ADDENDUM NO. 1
CONTRACT: RDSD 17-10
DATED: APRIL 17, 2018

TOWN OF RIVERHEAD
RIVERHEAD SEWER DISTRICT

211 EAST MAIN STREET SANITARY SEWER IMPROVEMENTS

A. SHEET C2.0

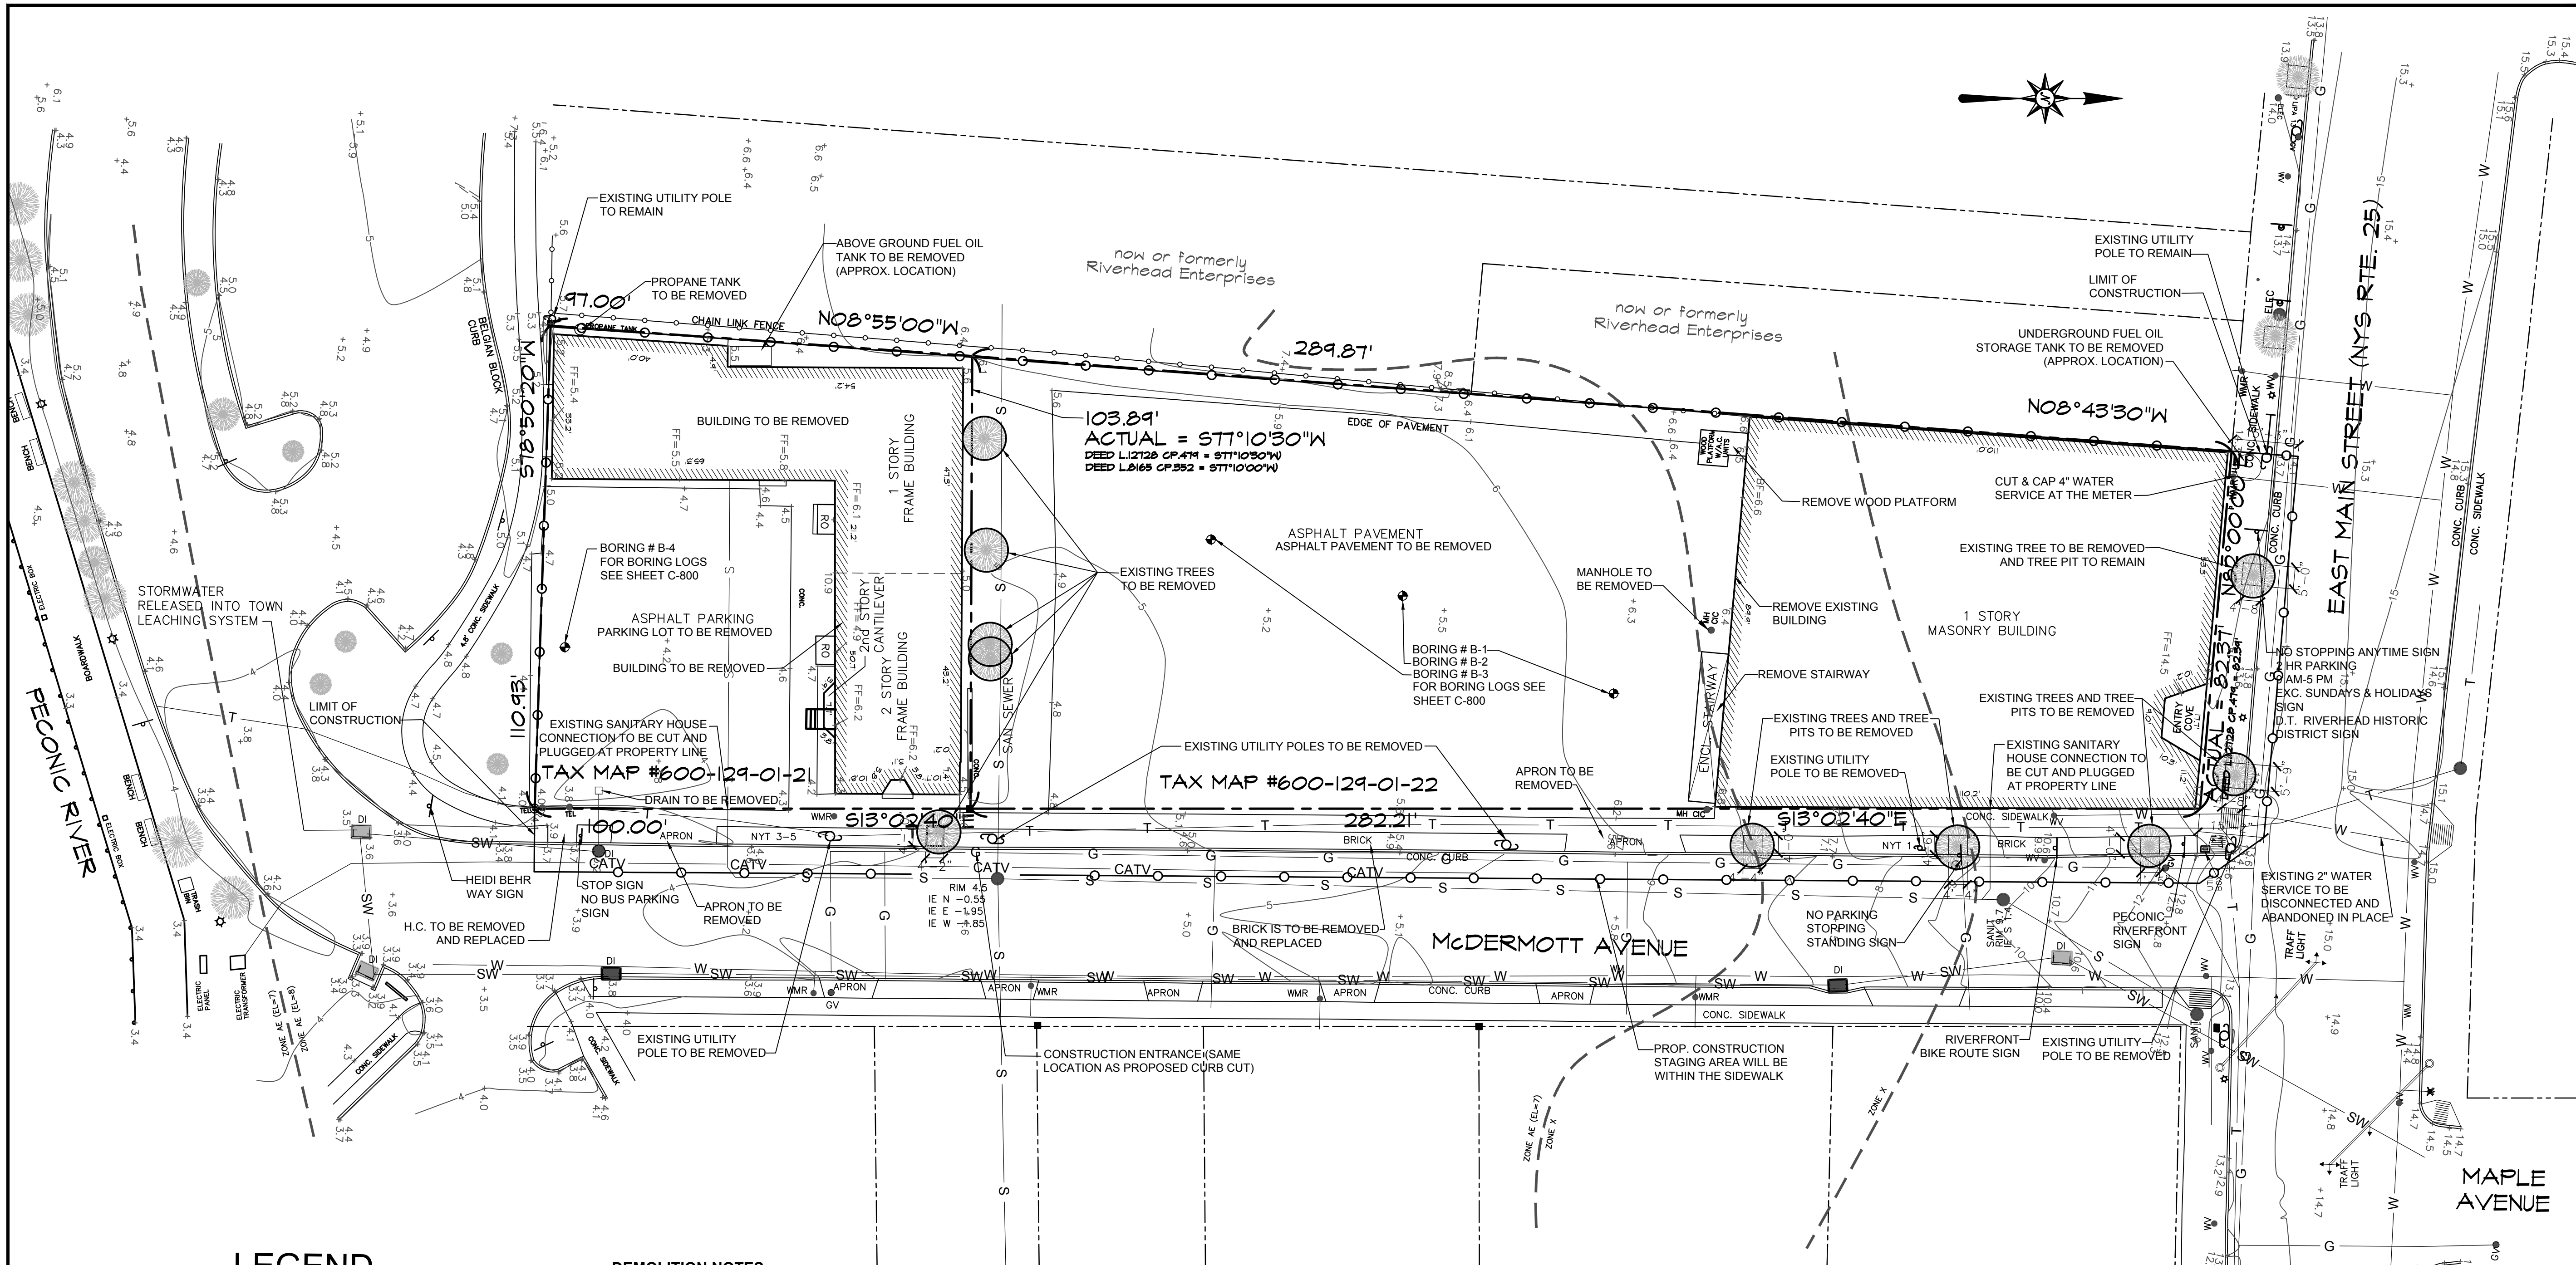
1. REPLACE on sheet all references to "12" Ø DR-18 PVC" with "12" Ø CLASS 52 DUCTILE IRON".

2. ADD to SANITARY SEWER INSTALLATION NOTES Note 3 "CONTRACTOR SHALL COORDINATE SEQUENCING OF SEWER INSTALLATION AND CONCRETE PLACEMENT WITH DEWATERING OPERATIONS PERFORMED BY OTHERS. CONCRETE PLACEMENT SHALL BE ALLOWED IN MINIMUM 20-FOOT LENGTHS ALONG ENTIRE ENCASEMENT ALIGNMENT; LARGER LENGTHS MAY ALSO BE ALLOWED. EACH POUR SECTION SHALL INCLUDE THE COMPLETE CROSS-SECTION OF ENCASEMENT AREA. COLD JOINTS ALONG THE VERTICAL PLANE OF THE EXCASEMENT WILL NOT BE ACCEPTED. SUBMIT TO ENGINEER FOR REVIEW PRIOR TO BEGINNING WORK WRITTEN DESCRIPTION OF CONCRETE POUR SCHEDULE."
3. In Note 5 under Sanitary Sewer Installation Notes, REPLACE at the end of the first sentence "... OFFSET THREE (3) FEET TO THE SOUTH OF THE EXISTING CAST IRON SEWER ALIGNMENT." with "...OFFSET THREE (3) FEET SOUTH FROM THE CENTERLINE OF THE EXISTING CAST IRON SEWER ALIGNMENT."
